SOUTH PETERSFIELD RESIDENTS ASSOCIATION

To: Policy and Regulations
Cambridgeshire County Council

TRO: Mill Road Bus Gate Order 20

South Petersfield Residents Association (SoPRA) **objects** to the TRO in its currently proposed form. We want urgent action on improving the safety of Mill Road for people walking and cycling, and enhancing its attractiveness as a destination. However, we are unpersuaded that a bus gate on Mill Road bridge will achieve this, especially for the part of Mill Road in Petersfield (west of the bridge).

Figure 1: Eight camera traffic monitoring locations required to capture all trips into or through the Mill Road area

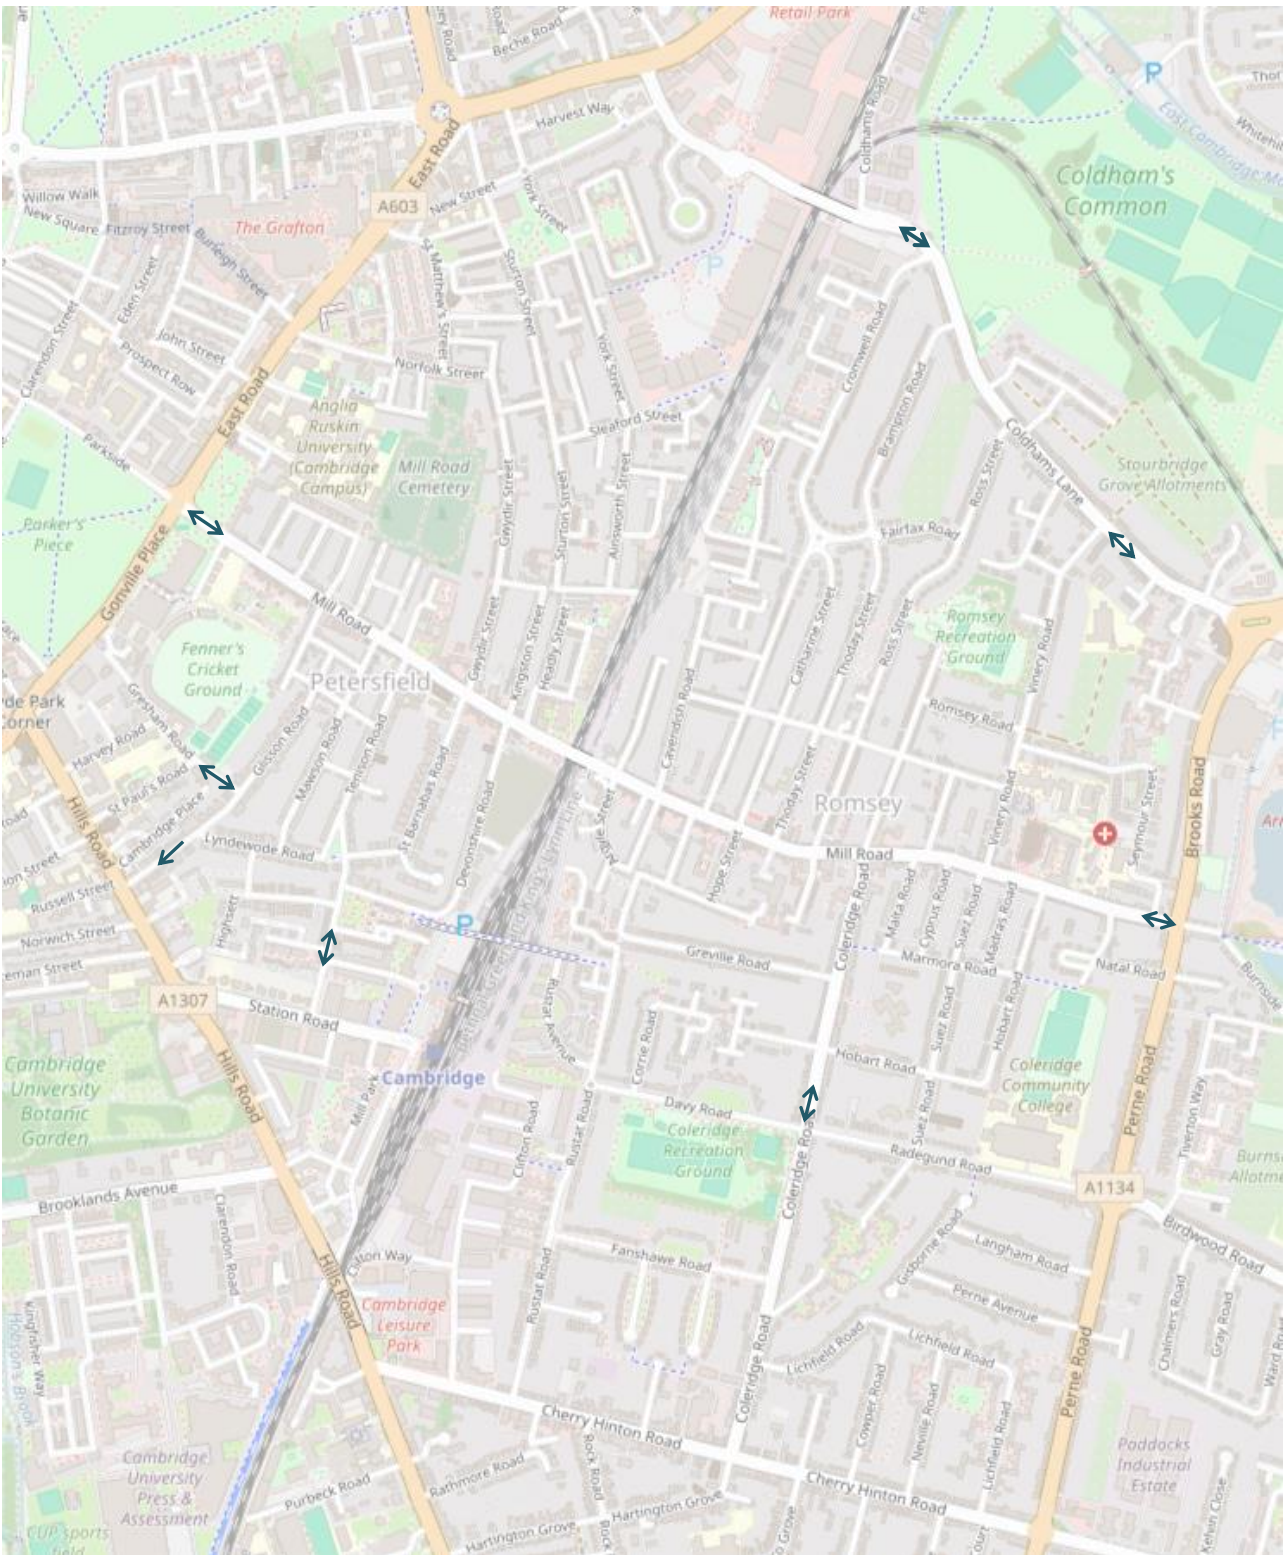
For all these reasons, we ask the Council to commit to monitoring traffic and publishing the data before and after installing any intervention that will significantly alter traffic flows. This is so that the Council and residents can build an accurate picture of the impacts. Ideally this would be achieved by setting up ANPR cameras and analysing the data to see how trips re-route or disappear. We suggest eight locations for monitoring traffic flows in both directions, as illustrated in Figure 1.
